Douglas Corner Retail Building Preliminary Development Plan

PL2023-111

August 8, 2023

1 WEST ELEVATION
1/8"=1'-0"

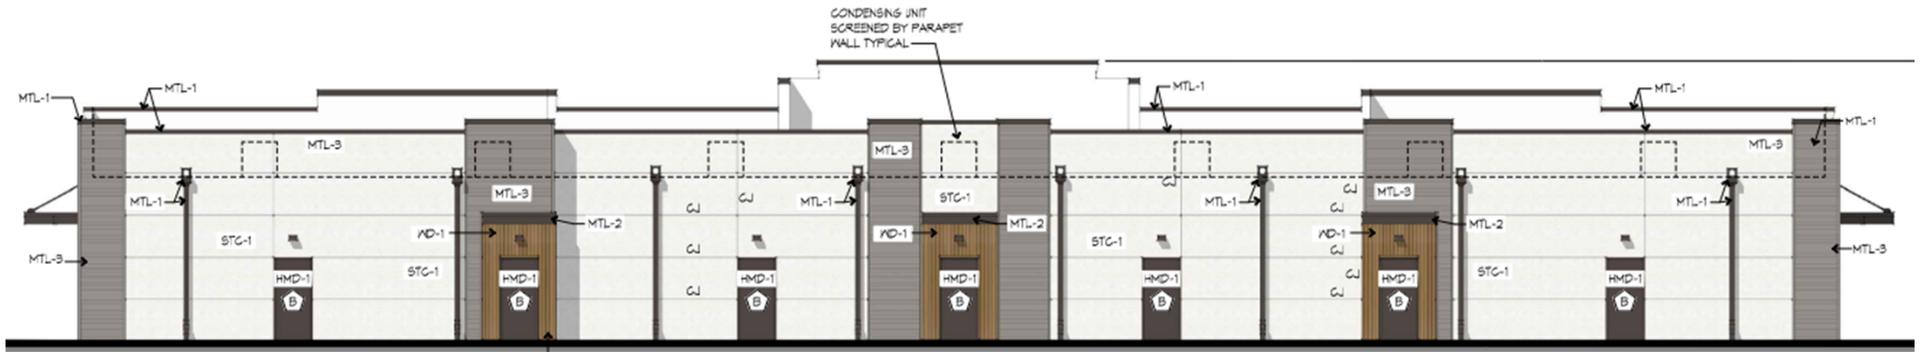
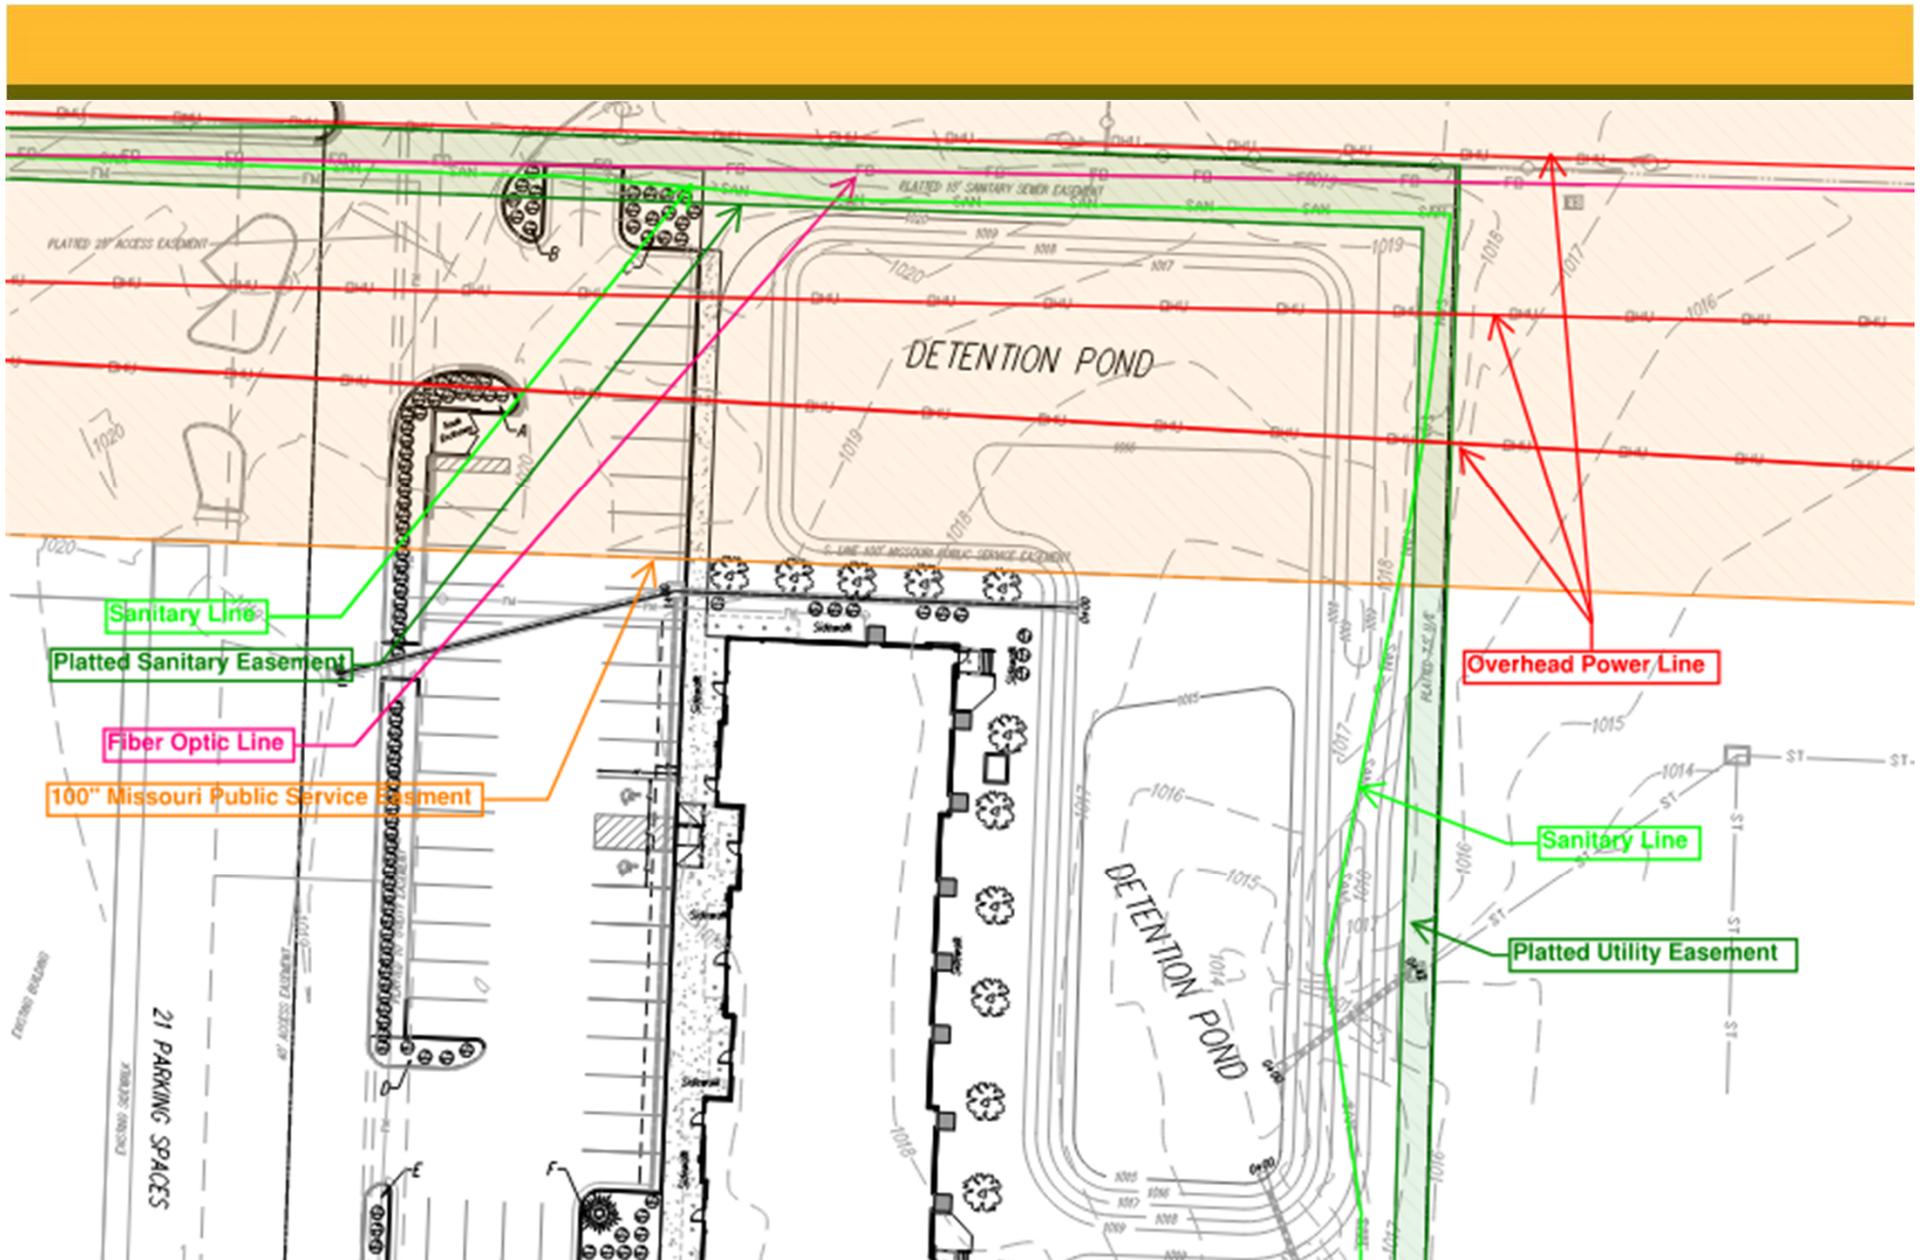
- The applicant has requested the use of architectural metal panels.
- UDO restricts building materials to masonry, concrete, stucco, and glass in the CP-2 zoning district.
- Metal is limited to an incidental role or as other architectural metal siding as approved by the Planning Commission and/or City Council.

6. The use of architectural metal panels shall be allowed as a conditional material as depicted on the building elevations dated June 26, 2023.

Proposed Trash Enclosure

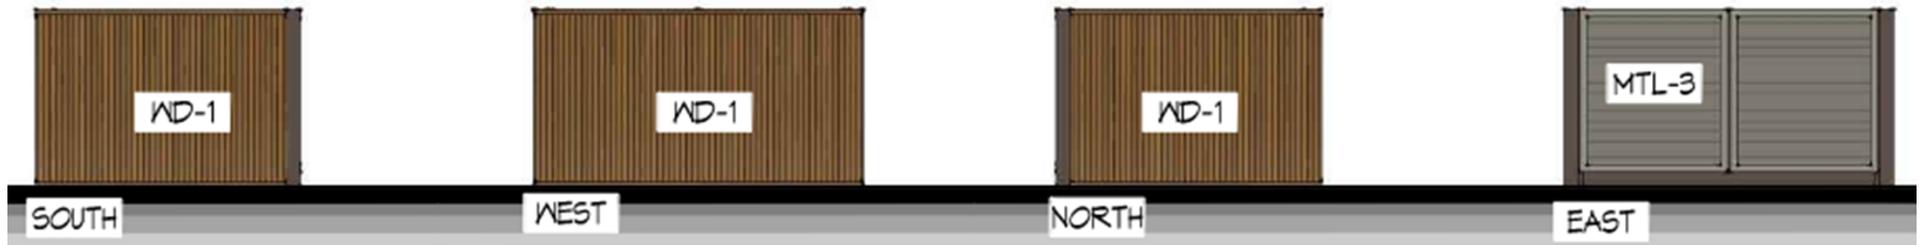
Proposed –

The applicant has requested the use of composite wood panel system for the walls of the trash enclosure.

3. A modification shall be granted to the trash enclosure design requirements to allow for the use of composite wood panel system for the walls of the trash enclosure as depicted on the building elevations dated June 26, 2023.

Similar Trash Enclosure at 216/218 SE Douglas St

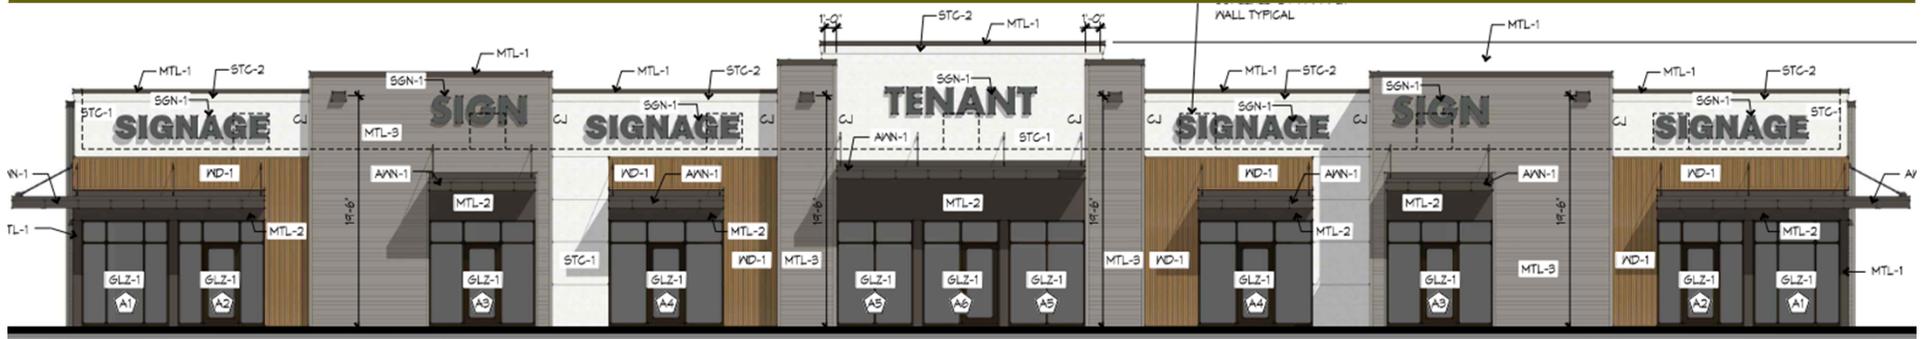
Required –

All trash enclosure shall be constructed of masonry walls or steel architecturally designed walls with either a solid steel opaque gate painted to be compatible with the color of the masonry or steel walls and building it is to serve or a steel framed semi-opaque gate with a screen mesh material approved by the Director that provides an appropriate visual barrier.
